Charlotte Historic District Commission

Agenda Supplement

October 6, 2025

CONTINUATION LETTER AND RESPONSE

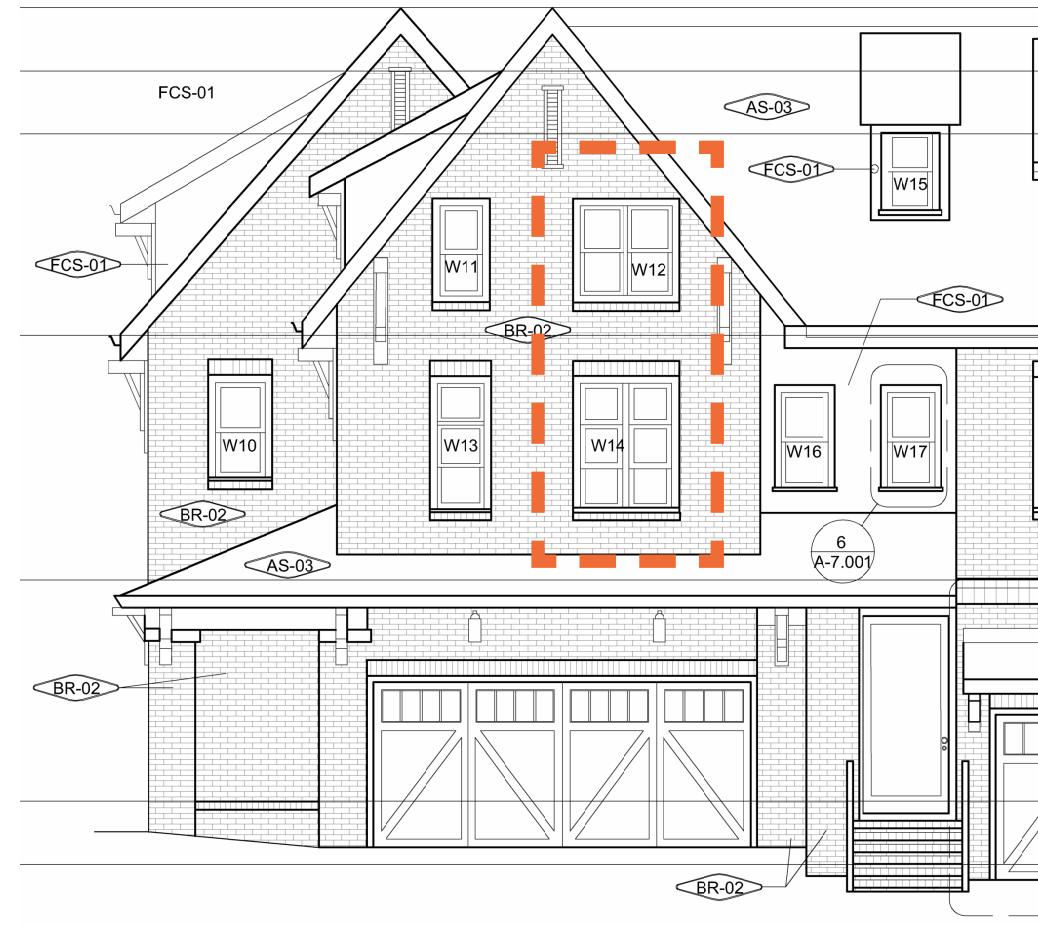
- c. Provide technical information to support the through-wall flashing and why that is required for this application. [Slide 10 of the supplement]

- 3C. INDUSTRY RECOMMENDED FLASHING DETAILS AT PROVIDED BY THE NATIONAL ROOFING CONTRACTORS ASSOCIATION (NRCA) HAND BOOK. THIS IS AN INDUSTRY WIDE ORGANIZATION THAT ESTABLISHES BEST PRACTICES. SLOPED SHINGLE TO BRICK HEADWALL DETAILS ARE PROVIDED. MINIMUM BASE FLASHING OF 4" ABOVE THE ROOFING SURFACE WITH A MINIMUM OVERLAP OF 2" OF THE OUTER REGLET FLASHING FOR A MINIMUM 6" TOTAL DEPTH. THIS PROTRUDES INTO THE ROWLOCK AND THE DECISION WAS MADE TO EXTEND THE FLASHING OVER THE ROWLOCK. WE WILL RECOMMEND CUTTING THE FLASHING DOWN TO TERMINATE UNDER THE ROWLOCK.

SOUTH ELEVATION

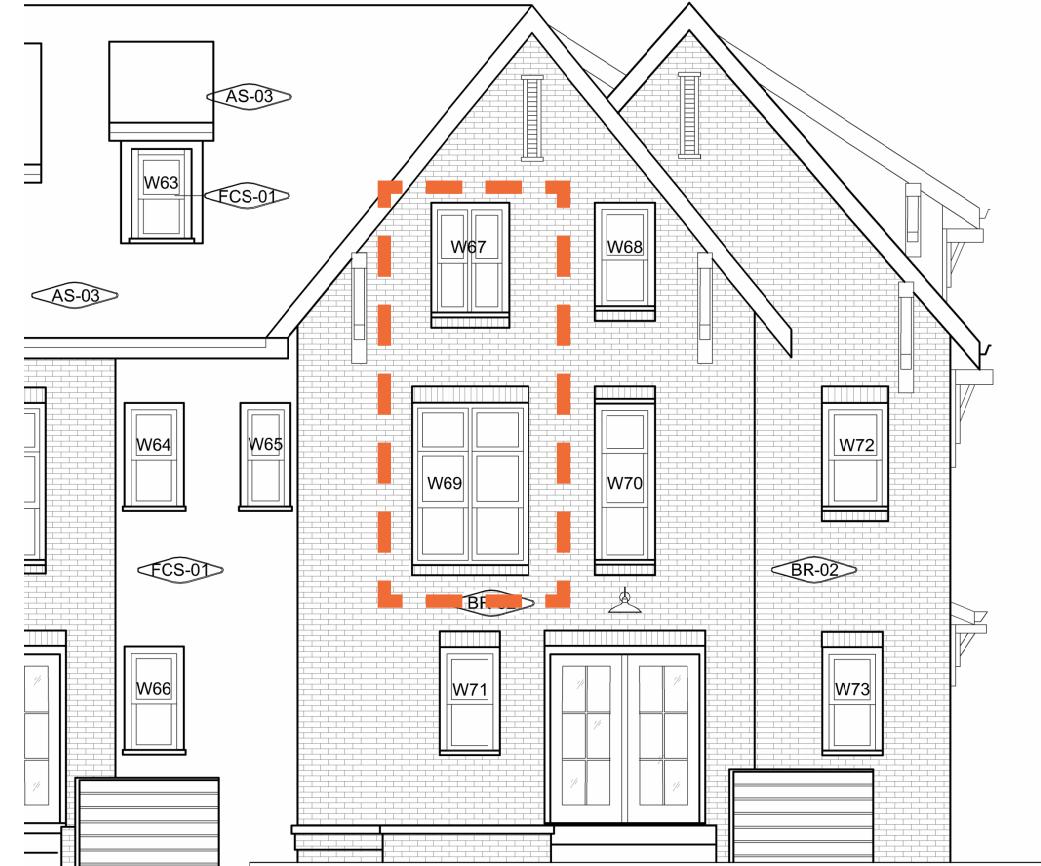
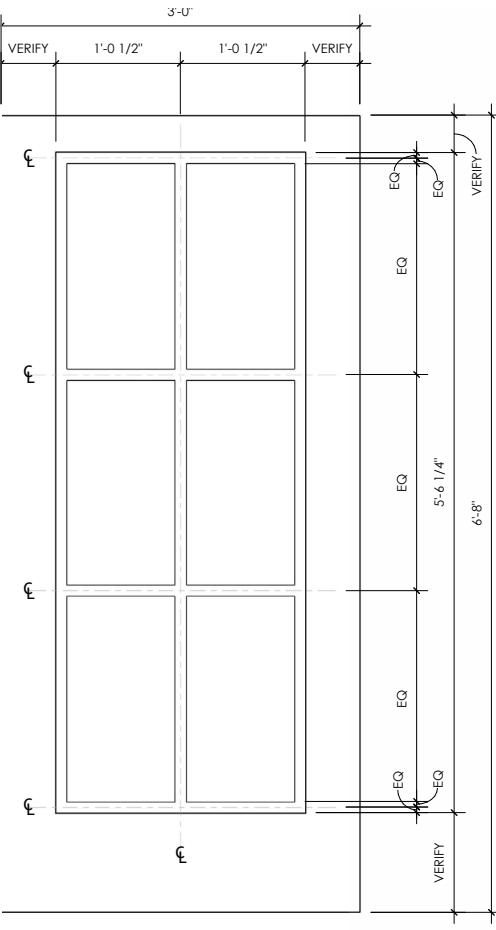
- 1. Doors and Window Changes, per Design Standards 6.15.**
 - a. Requesting a restudy of the second and third-floor windows anywhere that was changed from the approved design for the window type and/or glass size, so that the lower window presents itself as being equal or bigger than the top window, because the proportions of the light as existing is inconsistent with our standards. [Slide 4 of the supplement]**

Replace existing upper window sashes (window W12) with custom 2 over 2 sashes to match the rhythm of the mullion / mutton spacing on the window below

Replace existing upper window sashes (window W67) with custom 2 over 2 sashes to match the rhythm of the mullion / mutton spacing on the window below

PROPOSED ONE LITE DOOR

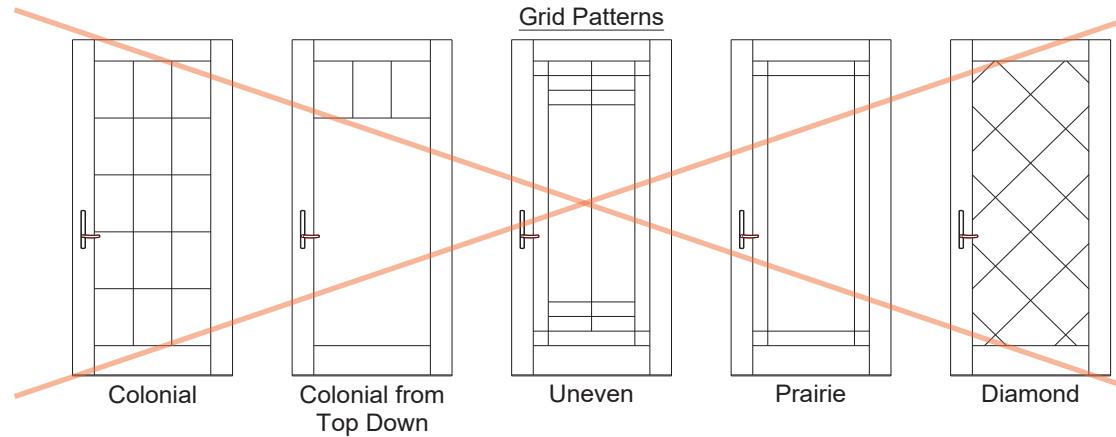
- b. Resubmit an alternative door configuration that meets our design standards. [Slide 5 of the supplement]
- 2. **Boxing Details and Gutter Changes per Design Standards 6.14.**

- 1B. PRIMARY PUBLIC STREET FACING DOORS SHALL BE 1/3 GLASS CRAFTSMAN STYLE DOORS PER THE APPROVED COA DOCUMENTS (DOORS FACING THE PLAZA)
SECONDARY PUBLIC STREET FACING DOORS SHALL BE FULL GLASS 6 PANEL DOORS STYLE DOORS PER THE APPROVED COA DOCUMENTS (COLYER AND THURMOND)
PRIVATE STREET AND ALLEY FACING DOORS SHALL BE FULL LITE GLASS DOORS.

5 ROOF BRACKET
AB005 SCALE: 1 1/2" = 1'-0"

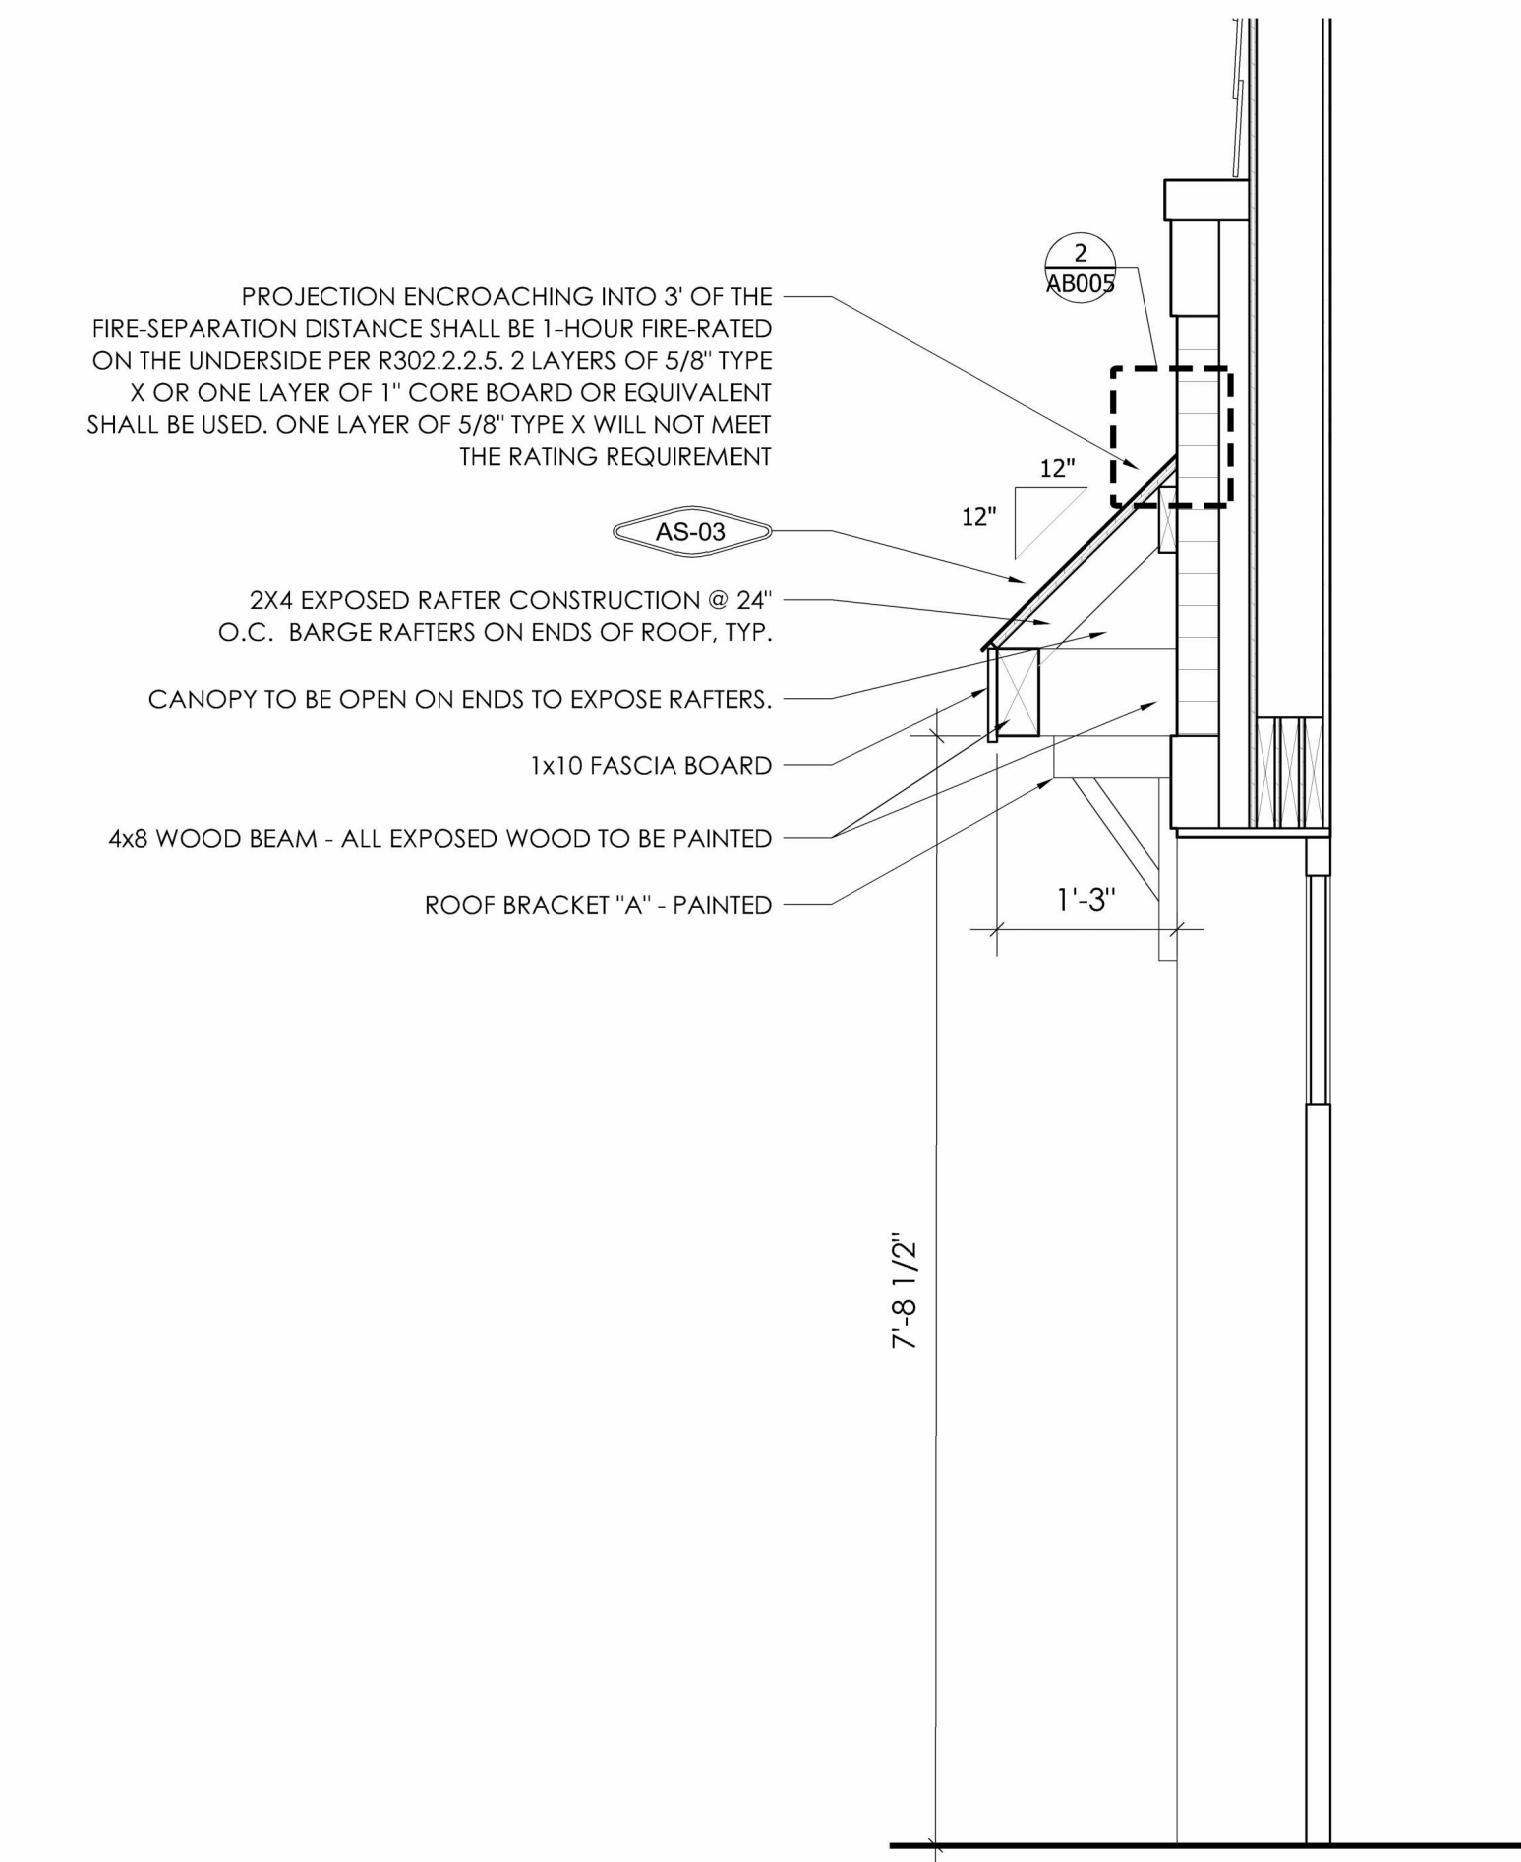
- 3. **Column and Header and Bracket integration, per Design Standards for Masonry 5.5 and Cornices and Trim 6.14**
 - a. The overall project needs to be reviewed for bracket size and scaling. The column and header and bracket integration as approved on the drawings have a minimal offset between the header and the column. Reevaluate the dimensional offset between the column and the header and how the bracket size and integration worked with those design details, how the bracket worked with the column and the header and how they connect to each other, but also the bracket size specifically. [Slide 7 of the supplement]

- 3A. SEE ATTACHED AND REQUESTED CONSTRUCTION DOCUMENT LEVEL DRAWINGS AS REQUESTED FOR THE COLUMN AND BRACKET INTEGRATION. - SEE ATTACHED DETAIL SHEET
- 3B. THE DIAGONAL DESIGN WAS REVIEWED AND APPROVED DURING THE INITIAL ISSUANCE OF THE COA. THE ONLY DEVIATION NOTED FROM THAT APPROVAL IS THE CENTER BAY OF THE THREE PANEL DESIGN. WE ARE REQUESTING APPROVAL TO CHANGE THE CENTER BAY SIDING FROM A VERTICAL ORIENTATION TO A HORIZONTAL. IF THIS IS NOT ACCEPTABLE, THE VERTICAL LAP SIDING WILL BE PROVIDED IN THE CENTER BAY ONLY PER THE APPROVED COA DOCUMENTS

1 ROOF RAKE TO EAVE TRANSITION
AB006 SCALE: 3/4" = 1'-0"

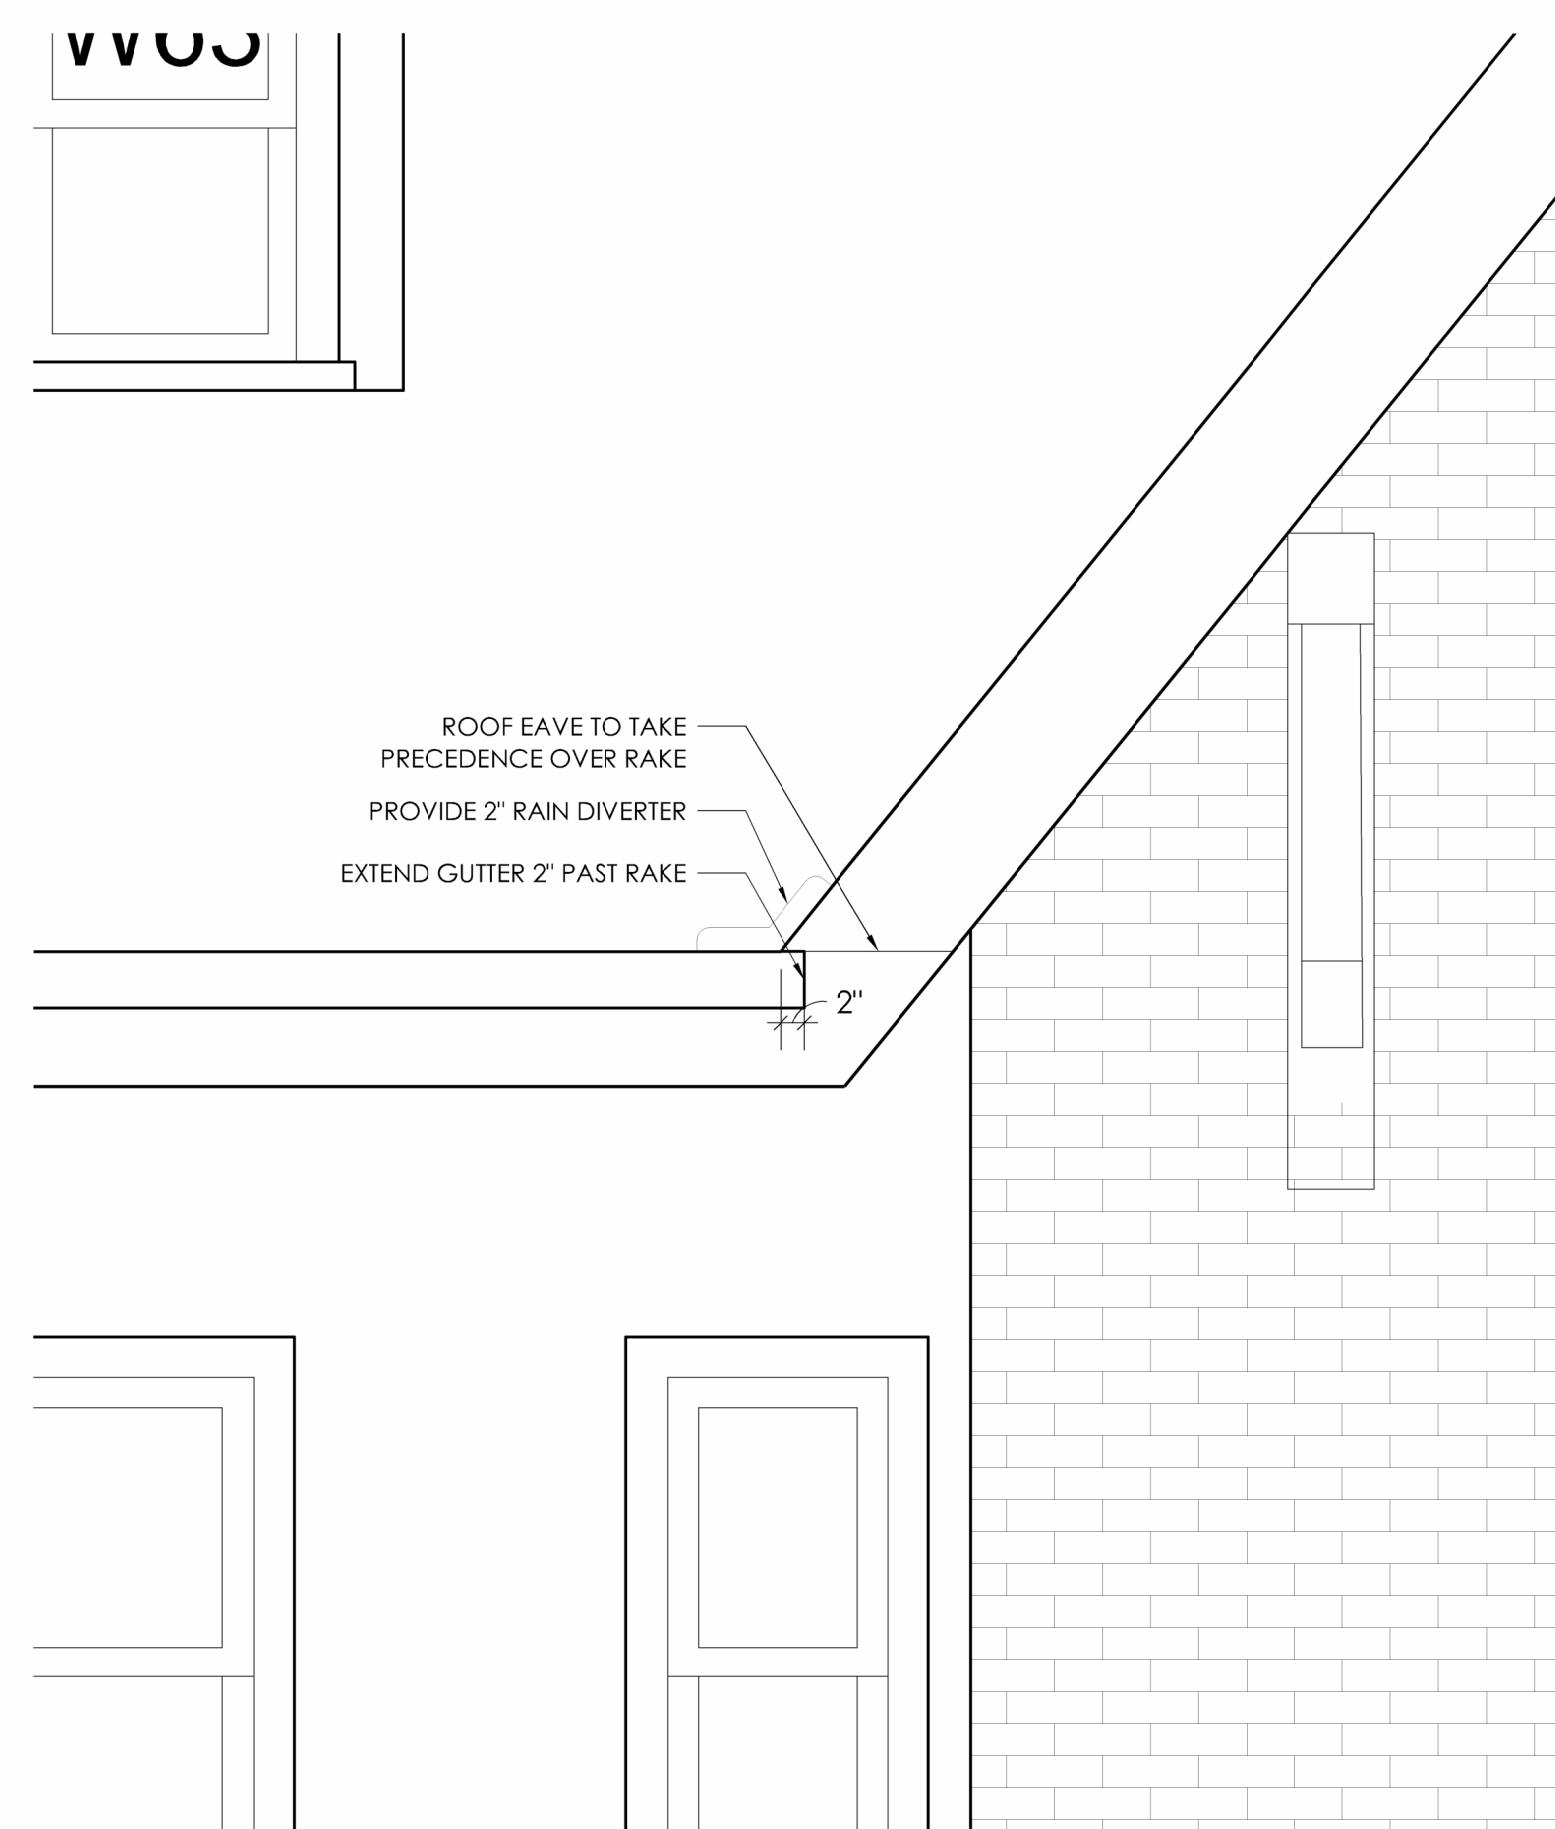
- a. The boxing details for the roof rakes and soffits are still inconsistent with each other. They typically don't match what was presented, but they also don't match each other in solution. There needs to be some consistency in the boxing detail. We approved an angled soffit, and we have been presented with a square boxed soffit and an angled soffit in different locations. [Slide 6 of the supplement]

- b. We do want the gutters to be reflected appropriately, as well, but that boxing information and the gutter information needs to be addressed as presented on that page. [Slide 6 of the supplement]

- 2A &B. ALL BOXING DETAILS SHALL REBUILT AND DETAILED PER THE ATTACHED IMAGE. DUE TO THE NUMBER OF DIFFERENT CONDITIONS AND FRAMING CONDITIONS WE WILL PROVIDE DETAILS FOR EACH CONDITION WHEN THE SELECTIVE DEMOLITION BEGINS AND IN PLACE FRAMING CAN BE EVALUATED. REQUEST TO WORK WITH STAFF AFTER APPROVAL OF THIS DIRECTION BY THE COMMISSION..

RAKE TO FASCIA TRANSITION- INTENT TO REPLICATE THIS DETAL AT ALL LOCATIONS FOR CONSISTENCY
